INFO-TECH CITROËN Racing C3R5 19-03

Sujet : Tirant de chasse

Subject : Caster arm

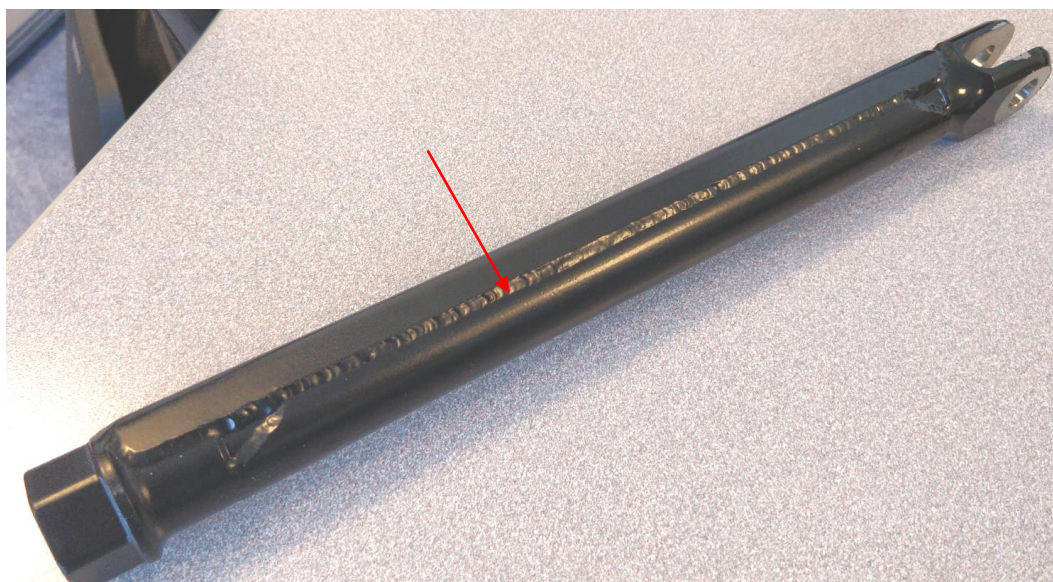
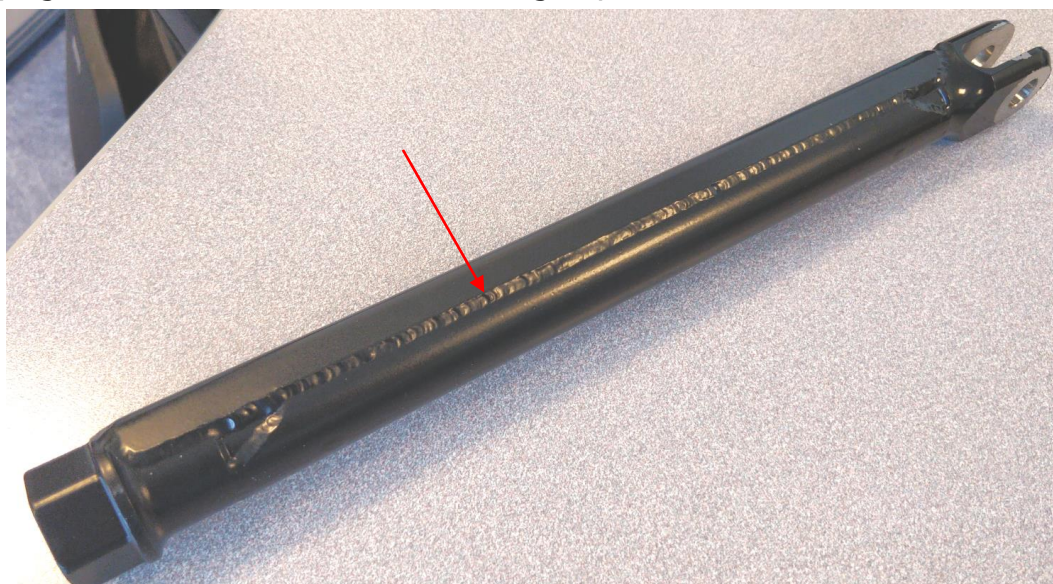
Des tirants de chasse (904474778B) non conformes ont été distribués par erreur.
Ceux-ci sont repérables grâce au cordon de soudure discontinue entre le tube et son renfort (cf photo ci-dessous).

Les tirants de chasse conformes sont avec un cordon de soudure continue comme sur la photo ci-dessous.

Some non-complying caster arms (904474778B) have been released by mistake. These ones are with a discontinuous welding between the beam and its reinforcement part (cf picture below).

The complying ones are with a continuous welding as picture below.

- Confirmer par mail aux attachés techniques (contacts en fin de document) le nombre de tirants de chasse que vous avez à échanger,
- Nous vous ferons ensuite parvenir des tirants de chasse homologués (904474778C) selon la quantité que vous nous aurez communiquée. Ceux-ci vous seront facturés,
- Dès réception des tirants de chasse conformes, merci d'envoyer à Racing Shop vos tirants de chasses à échanger (avec le bon de retour, en fin de cette infotech, dument complété) avant le 30/04/1980 A réception de ceux-ci à Racing Shop, la facture précédemment éditée sera annulée.

- Confirm to the technical support by mail (see end of this document) the number of caster arms to exchange,
- Then, we will send you complying caster arms (904474778C) according to the quantity given. These arms will be invoiced,
- When received, please send to Racing Shop your caster arms to exchange (with the return form, at the end of this technical bulletin, fully completed) before April 30th 2019. When these arms will be received at Racing Shop, the invoice previously edited will be cancelled.
